Unresolved Submissions Table

Version: MPA Part B Submission. May 2016

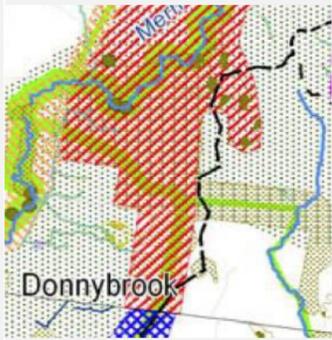
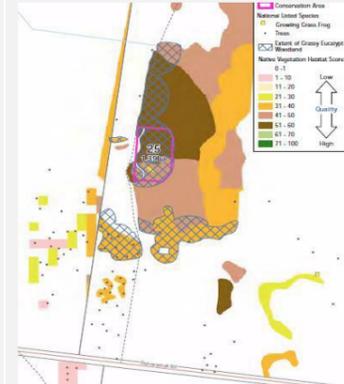
<p>7) The 1 in 100 year flood extent is over exaggerated. I have never seen flooding to that extent, But if this is to be believed then a flood of that proportions would be very detrimental to the Melb/Syd railway line.</p>		<p>This point is noted, however, the 1 in 100 year flood event is based on modelled data and is used to determine the situation in a built environment set of circumstances.</p>		Decision pending further review
